Address: 317 E Wilson Street

Title: Wilson Street Hotel

Re: Letter of Intent – Update for Final Submittal  
317 E Wilson St – Wilson Street Hotel

2022-4-11  
UDC FINAL SUBMITTAL

**PROPOSED  
PLAN-SOUTH ELEVATION**

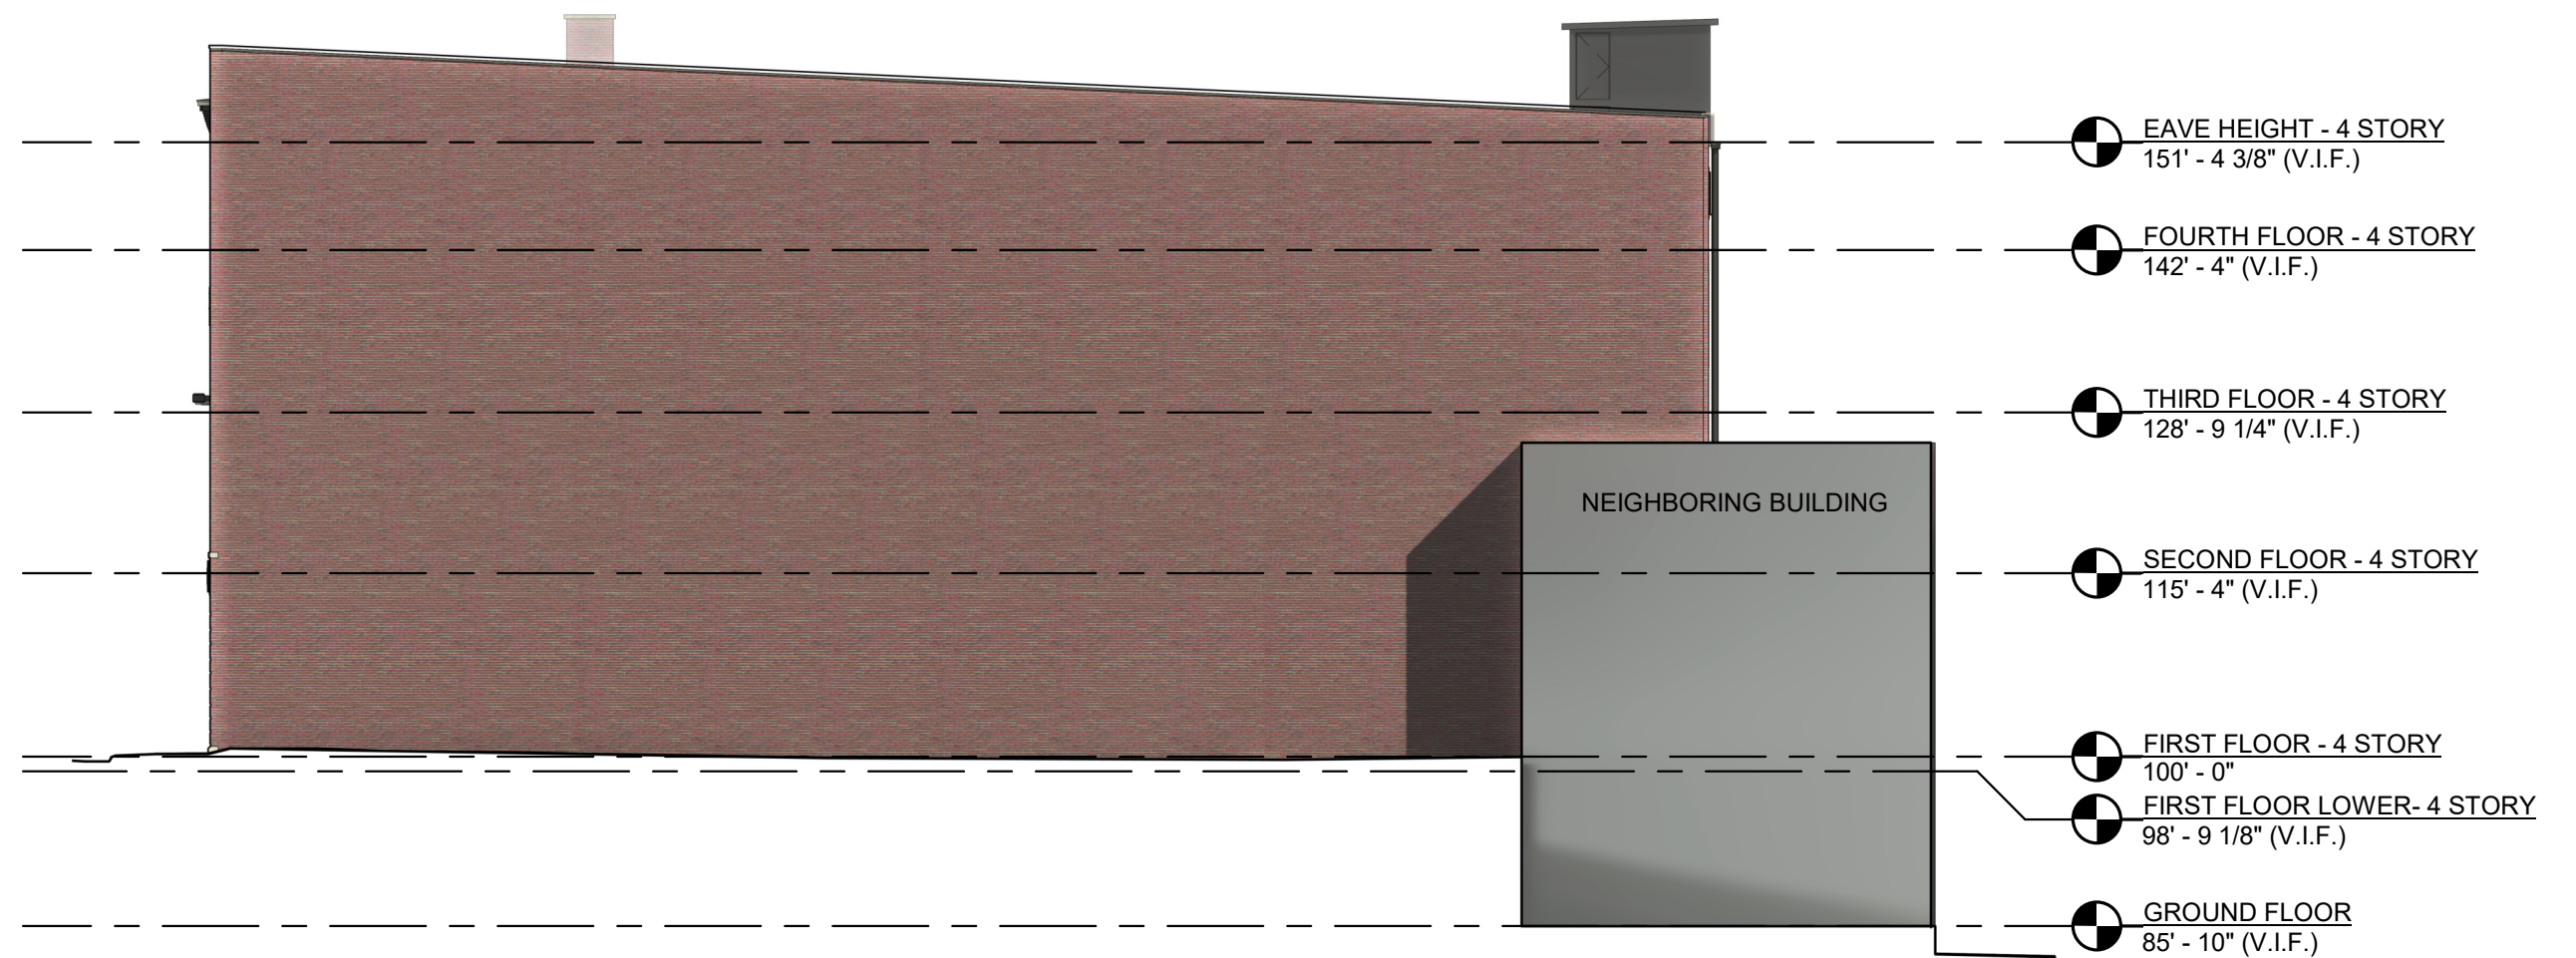
- Item 1: Review size of rear windows, consider providing larger openings for enhanced lake views.
- Item 2: The building appears too modern, look at different finishes to be more complimentary to the Historic Building.
- Item 3: Look into possibly wrapping the First Floor E Wilson finish onto the upper floors, also review window alignment between the first floor & upper floors.

- In response to Item 1: We have increased the Lake-facing corner unit window to be larger, providing a 3-pane window in-lieu of two separate, smaller windows.
- In response to Item 2: We have modified the stark white EIFS finish to be more beige, less stark white. We have also updated the darker color to be less black and more of a gray tone. We feel these new primary finish colors are less contrasting and more complimentary to the adjacent Historic Building.
- In response to Item 3, we have continued the stone / base building finish to wrap vertically & serve as the transition between the 2-story and historic buildings, we have also provided some re-sizing & re-alignment of some openings on first floor to better relate to the openings/ inset areas on second floor.
